The Blue line is a rough Idea of how we are planning to enclose all loads out of all 3 line ups in a shared crown box. We need to do this due to the room elevation being too short to accommodate independent conduits 90 degree elbows for all feeders.

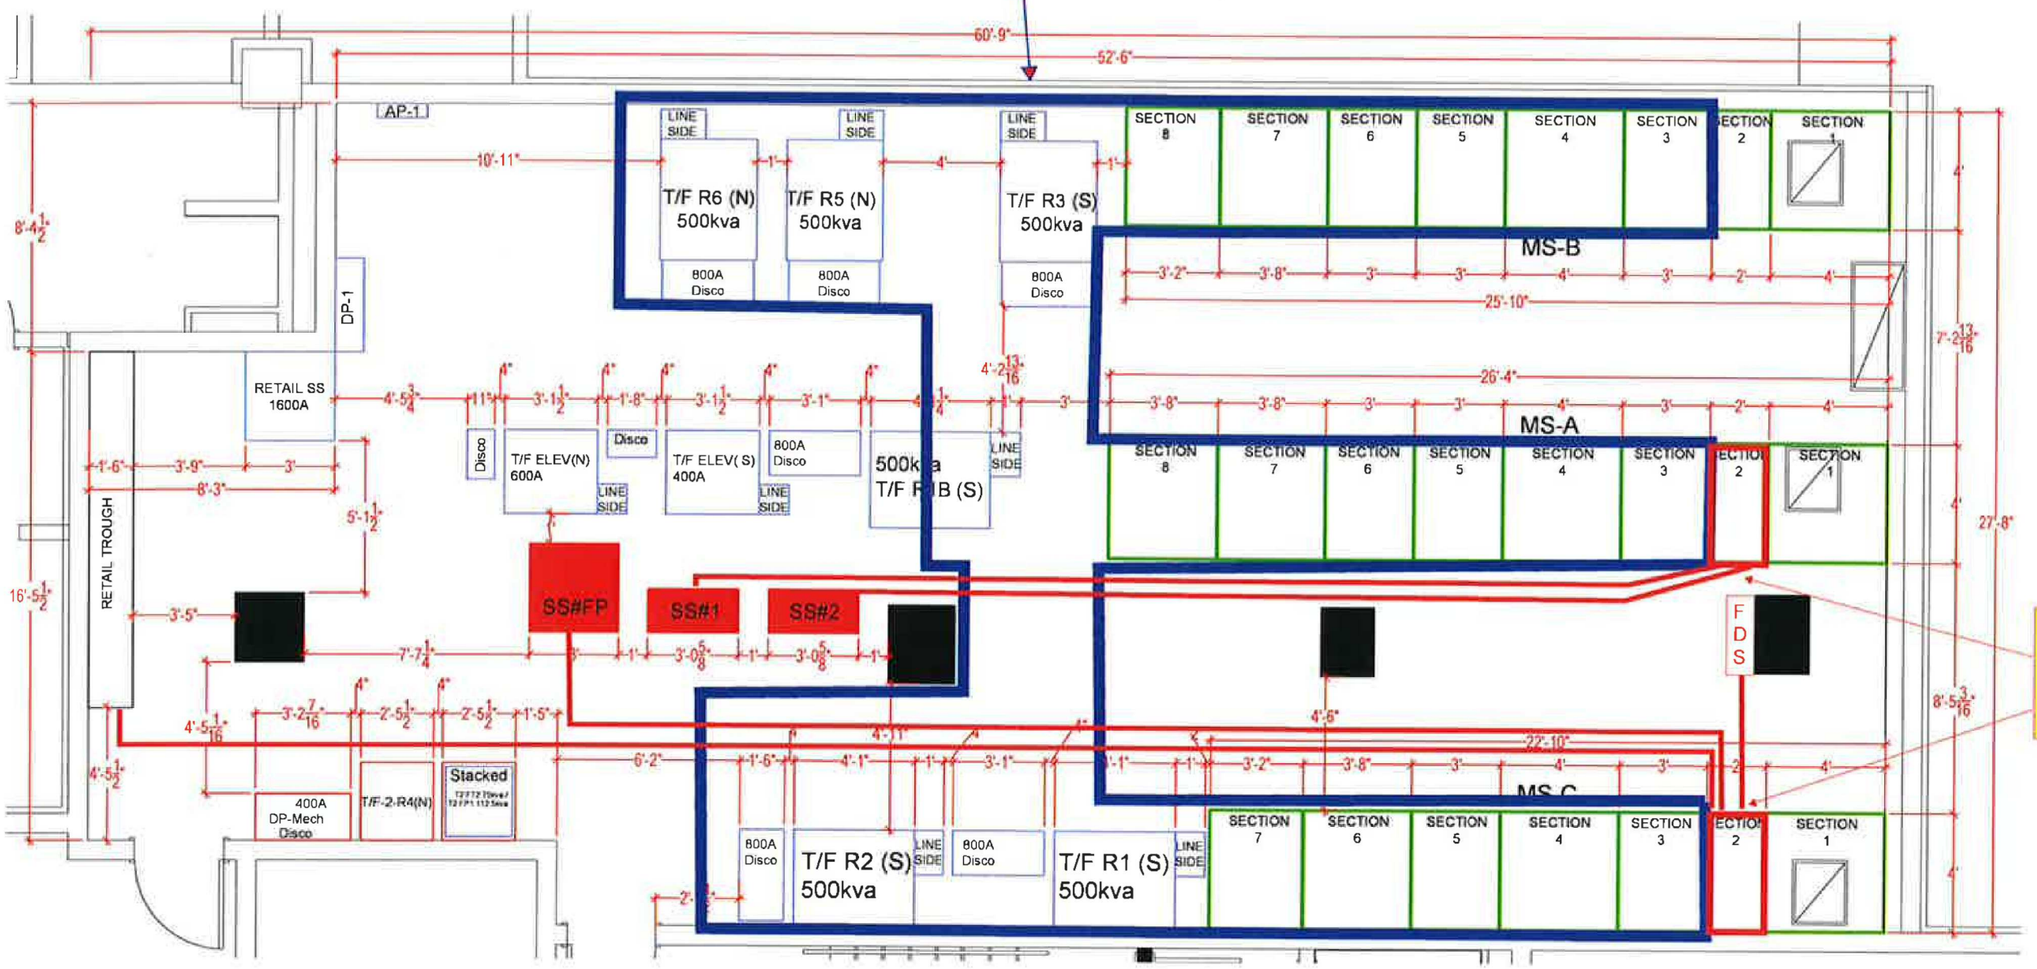
Fire Pump, FDS, and Retail trough feeders will be run straight to tap section in rigid conduit. The crown over tap section #2 in both line ups will be independently closed from the rest of the Crown enclosure.
